LOU-1564-G-172

LOUISIANA POWER & LIGHT COMPANY WATERFORD S.I. S UNIT NO. 3 1977 - 1165 MW INSTALLATION FLOW DIAGRAM REACTOR COOLANT SYSTEM			
SCALE NONE	APPROVED	DATE	
BY MECH			LOU-1564
DR RELEASED			G-172
BY CH	APPROV.	CH

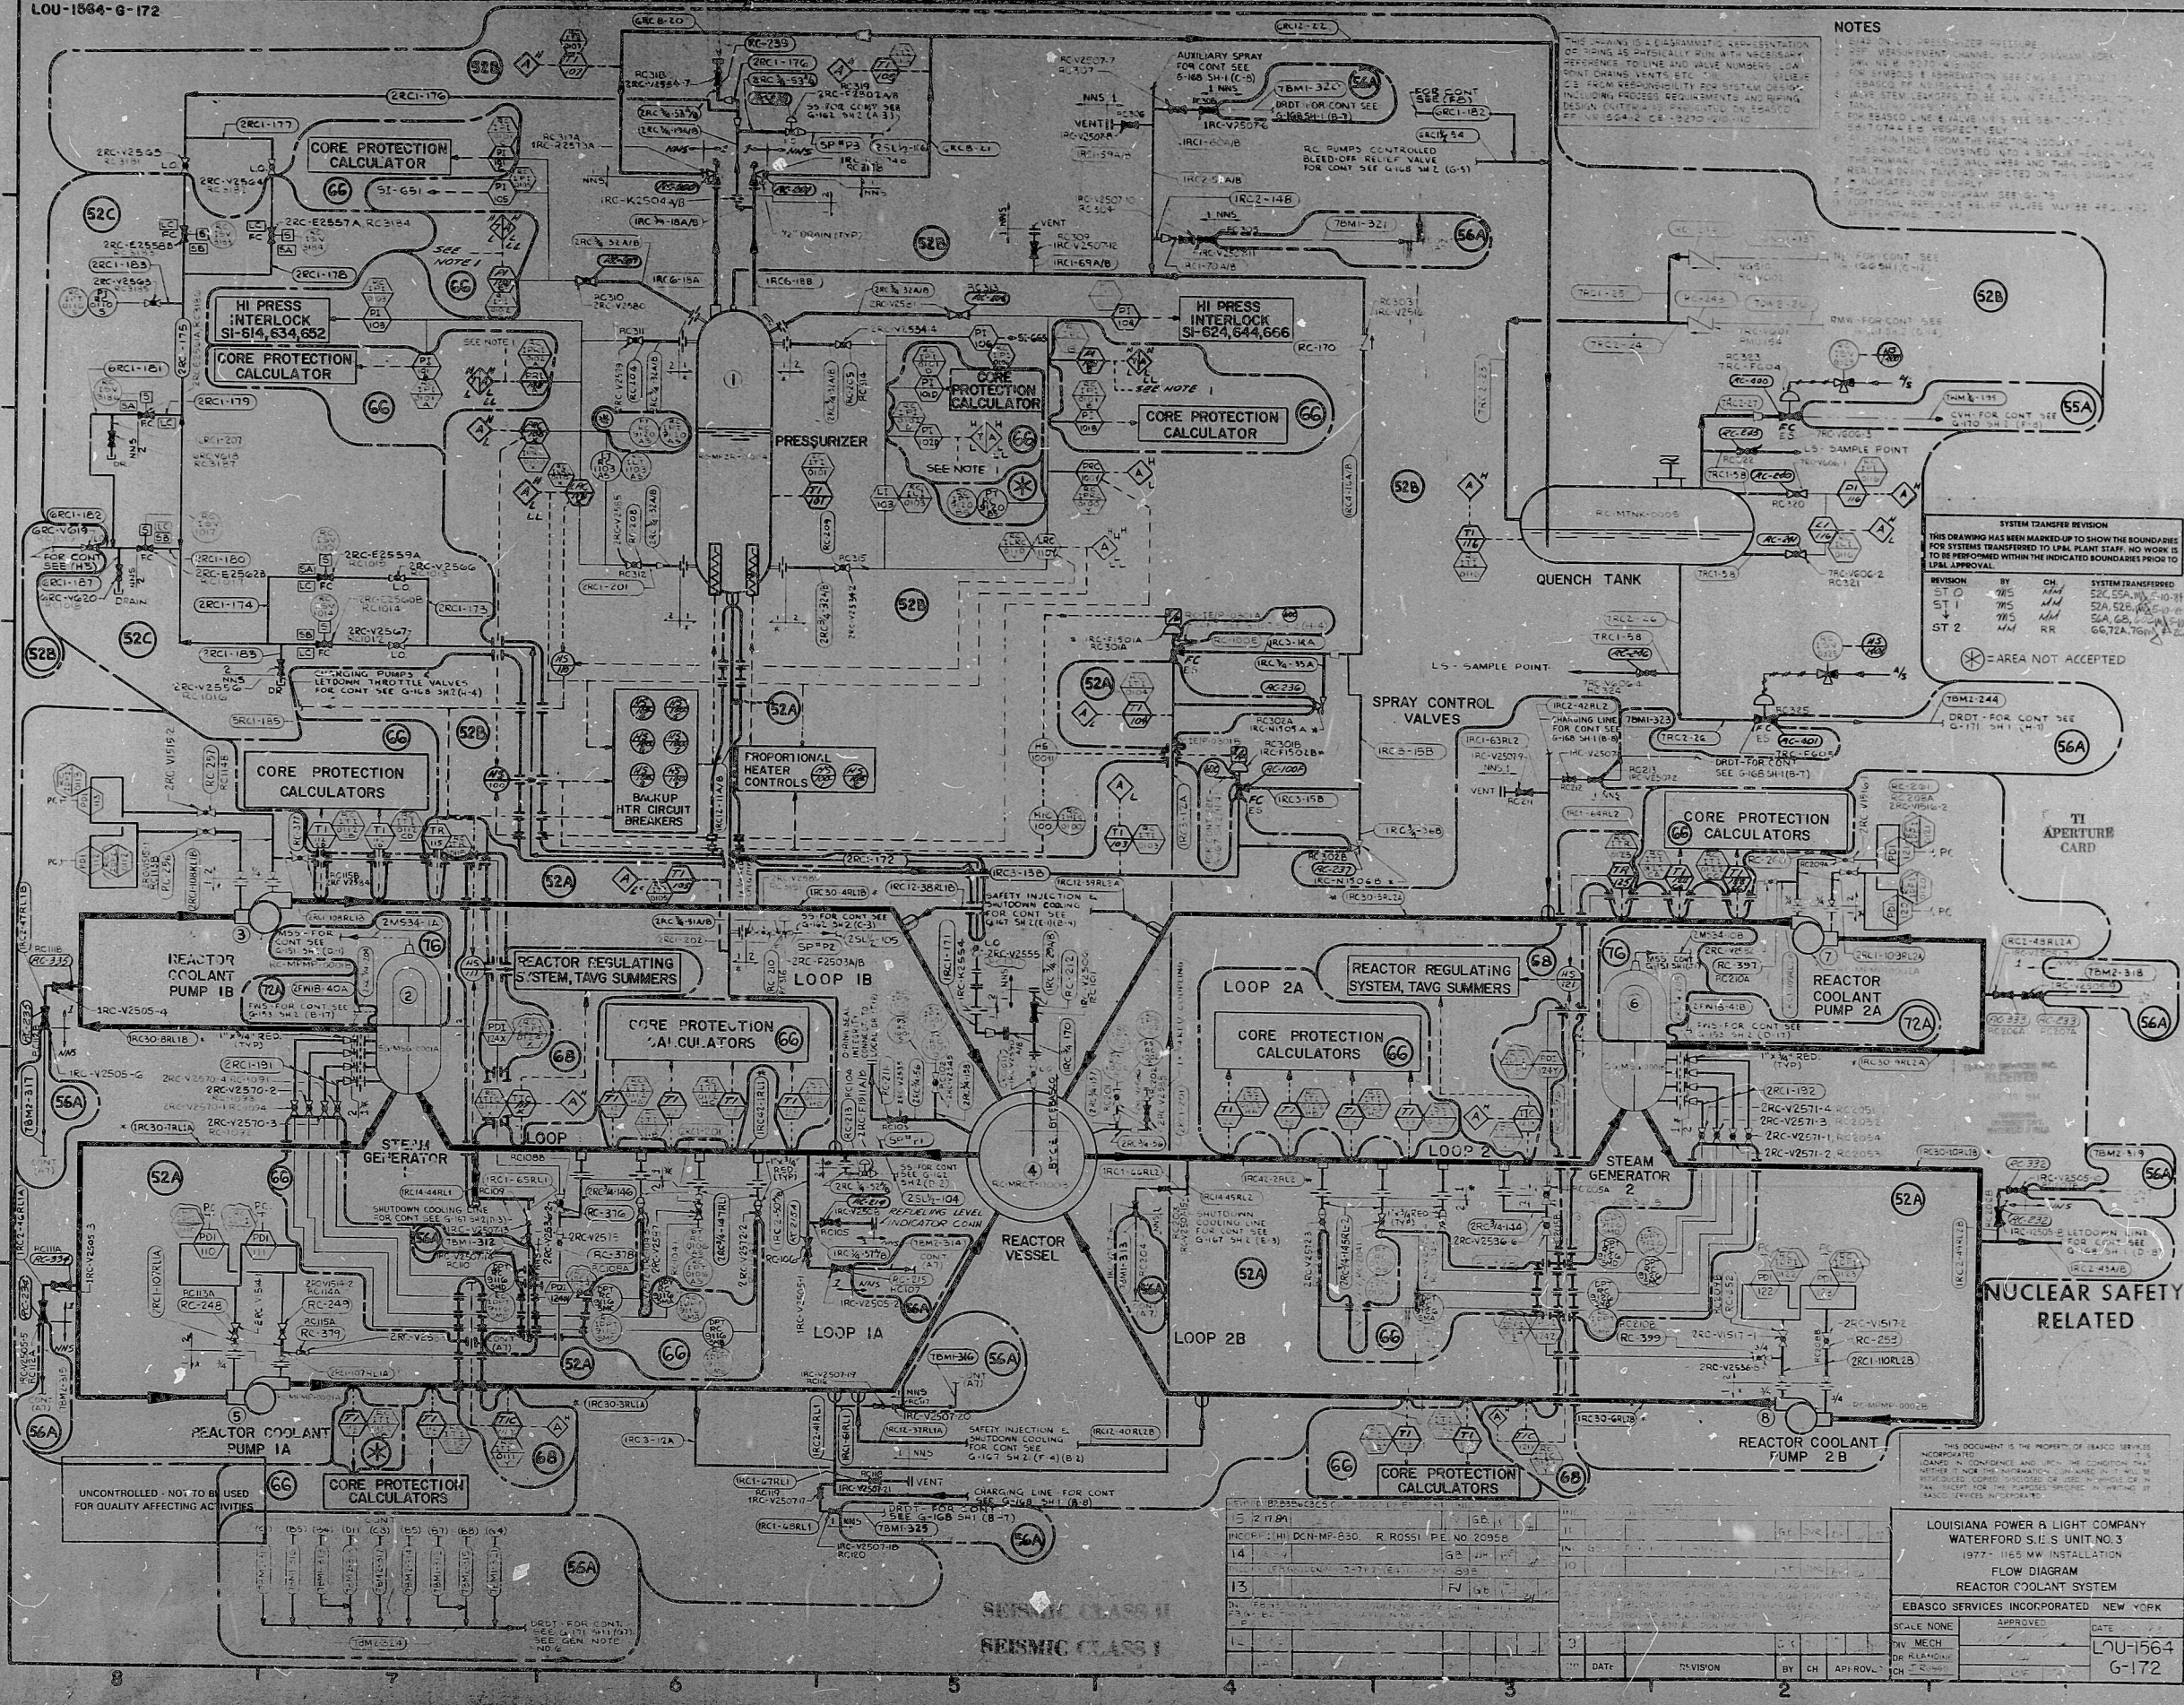
SYSTEM TRANSFER REVISION
 THIS DRAWING HAS BEEN MARKED UP TO SHOW THE BOUNDARIES FOR SYSTEMS TRANSFERRED TO LOCAL PLANT STAFF. NO WORK IS TO BE PERFORMED WITHIN THE INDICATED BOUNDARIES PRIOR TO LOCAL APPROVAL.
